Service Kit 753-05994

Subject: Service Replacement for the
682-0515A and/or 682-0516A Handle
Brackets

PURPOSE: This service kit contains the new handle brackets and additional parts required due to the new handle brackets configuration. The 682-0515A (Left Hand) and/or 682-0516A (Right Hand) handle brackets are no longer available. This kit must be installed in its entirety even if only one handle bracket requires replacement.

FIGURE 1

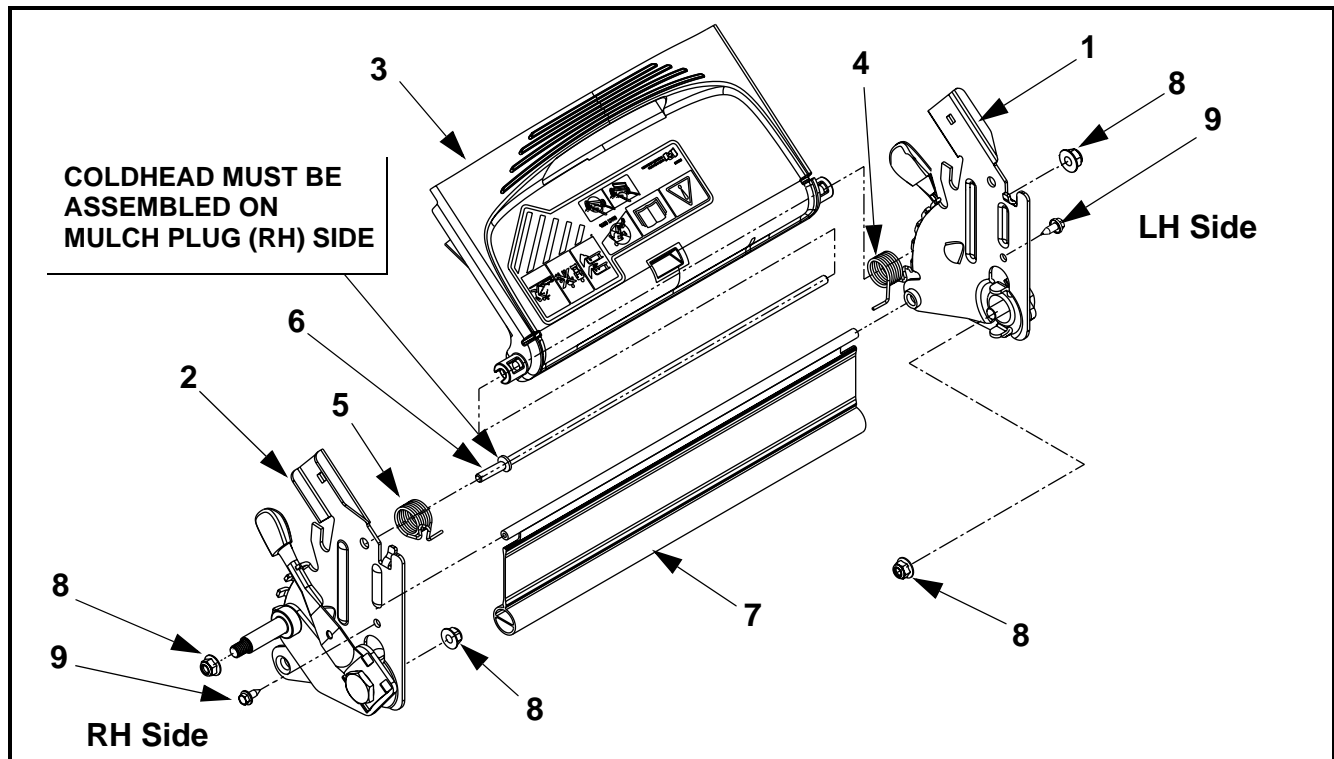
5. Remove the upper and lower handles (as an assembly) from the LH and RH handle brackets. Save all hardware.
6. Remove the wheels from the height adjusters. Discard the lock nuts.
7. Remove and discard the existing left and right side handle brackets, rear door, door pivot rod, door return spring(s), trail shield and hardware.

8. Install the Right Hand Handle Bracket, Item 2, to the deck first, using a **new** 3/8"-16 Flangelock Nut, Item 8, and a 1/4"-20 Taptite Screw, Item 9.
9. Slide the Rear Door Pivot Rod, Item 6, through the Plastic Door's upper hinges. Ensure that the coldhead end of the pivot rod is towards the RH handle bracket (mulch plug side).
10. Assemble the LH and RH Torsion Door Springs, Items 4 and 5, onto the pivot rod/door subassembly, ensuring the spring's straight arm is inserted in the door's molded in pocket. See Figure 2.

11. Install the trail shield into the RH handle bracket's trail shield hole.
12. Insert the left hand ends of the rear door pivot rod (with torsion spring in place) and trail shield into the LH Handle Bracket, Item 1.
13. Align the LH handle bracket to the deck and secure using a **new** 3/8"-16 Flangelock Nut, Item 8, and a 1/4"-20 Taptite Screw, Item 9.
14. With the rear door down and using a pair of long nose pliers and/or a flat blade screw driver, set the hook end of the door torsion springs onto the extruded tab on each handle bracket. See Figure 2.
15. Re-install the wheels onto the height adjuster axles using the **new** 3/8"-16 Flangelock Nuts, Item 8.
16. Re-install the upper and lower handle assembly onto the handle brackets using the hardware saved in Step 5.
